Delegated Report

Planning Application No: 20231101

Location: Land At Rosherville Way And Crete Hall Road Northfleet Embankment
East Employment Southern Parcel Rosherville Way

Description: EDC Consultation - Development of previously developed land to provide 3528m2 of employment floorspace, comprising Use Classes E(b) (Food and Drink), E(g)(i) (Office), E(g)(ii) (Research and Development), and E(g)(iii) (Light industrial) with associated site access, parking and landscaping.

Table 10.1: Summary of Recommended SSD Criteria

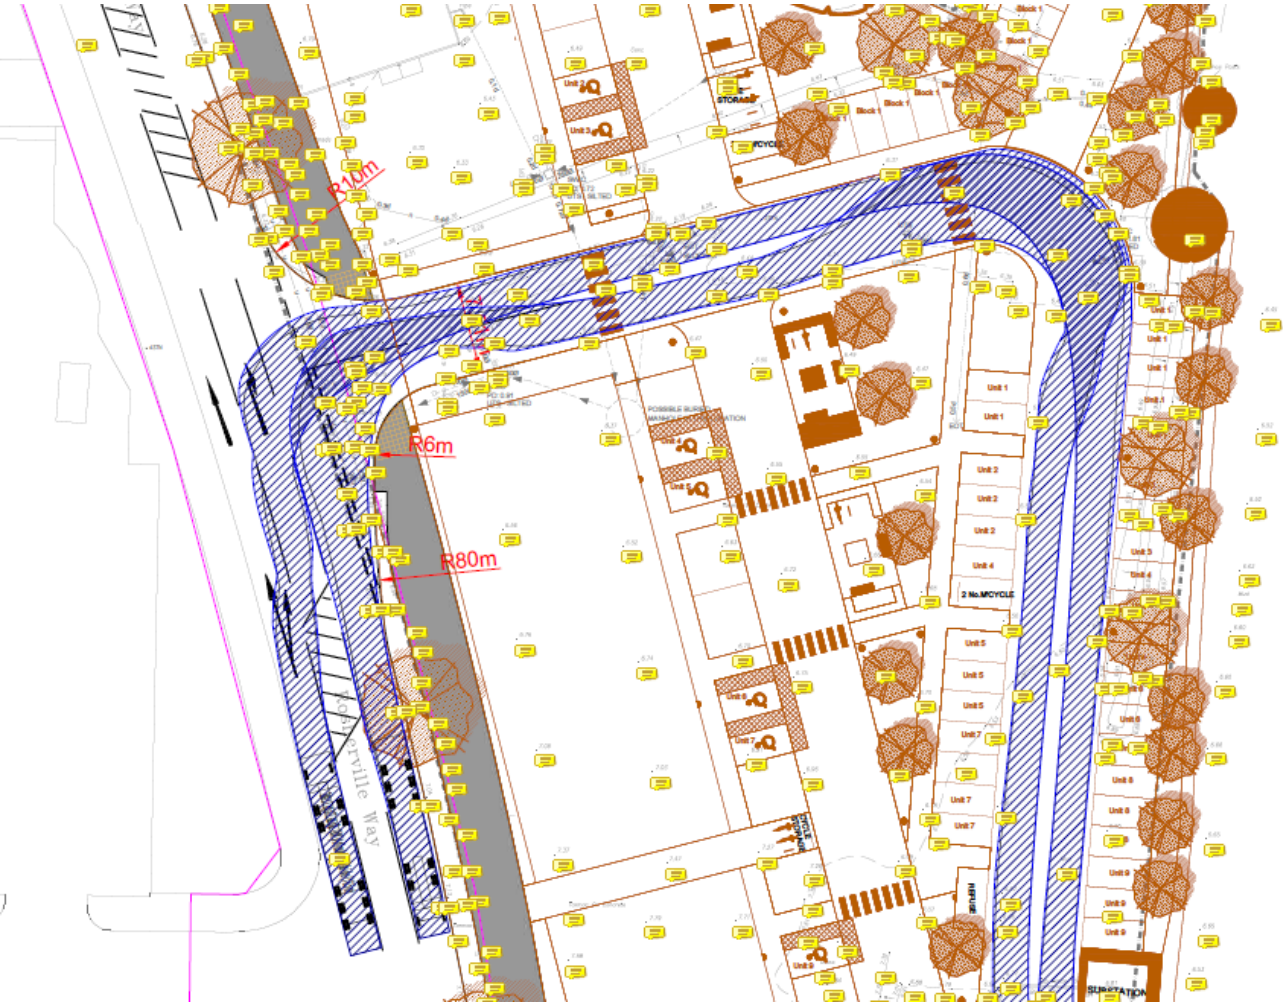
With reference to the type of vehicle that may visit the site, with increasing emphasis on minimising empty HGV trips, (not least caused by a lack of HGV drivers, but also as a desire to reduce pollution by reducing empty running) there is the possibility of deliveries and collections forming a part load on larger vehicle and so all vehicles should be readily accommodated and without the risk of collision. Care must be exercised when using Manual for Streets Guidance in relation to lorries and the adjustment for deceleration rate in Manual for Streets 2 should be used when considering visibility requirements for HGV's. It is noted that there is a threshold for using these figures when considering visibility requirements on exiting a junction where HGV and buses is less than 5% of flow, (no split of development flows or existing flows on the highway have been provided) subject to consideration of local circumstances, but this an area with a selection of other employment offers with their associated vehicle movements and so it is considered appropriate to accommodate the requirements of Manual for Streets 2

This increases the sight line requirement at 10mph to 12 metres, which is only a small increase, but an essential one when considering pedestrian and cyclist safety. Obviously, any increase in junction radii, would increase vehicle speeds and in turn visibility requirements. The radii at the junction is a matter for the Highway Authority as it will form part of the adopted highway and this should be agreed with Kent County Council adoption team prior to planning approval.

Extract from Drawing Number 15706-T-03 Rev P2 dated 29/08/23

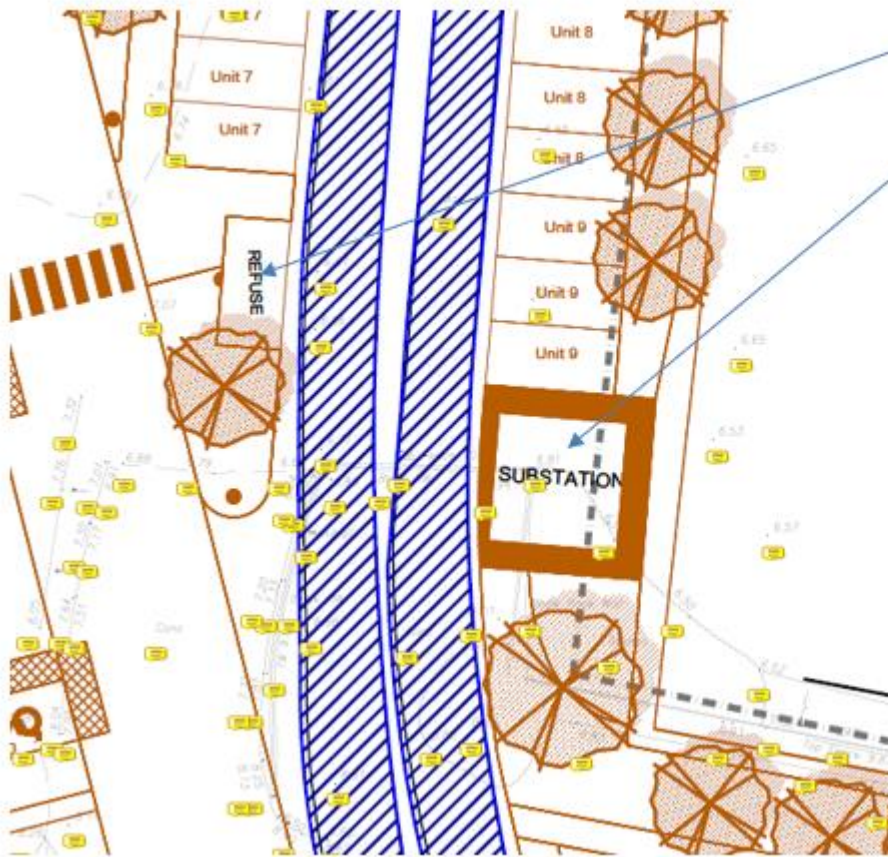
Whilst it is accepted this shows two articulated lorries passing, it does involve some conflicting

manoeuvres, which without adequate visibility will compromise highway safety.

1. A vehicle entering the site conflicts with a vehicle emerging and whilst vehicle speeds may be low and so the possibility of a collision may be avoided, it could result in one or both vehicle having to reverse to resolve the situation, and this could be hindered by following traffic. The vehicle entering may not come to a stop in the turning lane if its turn is unhindered by a vehicle travelling south. The radii and visibility should be improved to prevent this occurring.

2. The bend within the site requires vehicles to pass on the wrong side of the carriageway, to prevent collision adequate sight lines need to be provided. This is when people forget that approaching vehicles must be able to stop in time, so a collision is avoided, as such forward visibility needs to be doubled so that vehicles come to a halt just before they collide. So assuming a 10mph design speed the forward visibility requirement would be $2 \times 12\text{m}$ or 24m for HGV's. This would equally apply at any other collision point with distances varying depending on the design speed. Forward visibility splays should be plotted for the spine road for all relevant areas and the measures taken to ensure the design speed can be clearly achieved shown.

It is noted that the sight line for vehicles emerging from the spaces currently allocated to Unit 9 could be compromised by the proposed substation and for unit 7 by the refuse store.
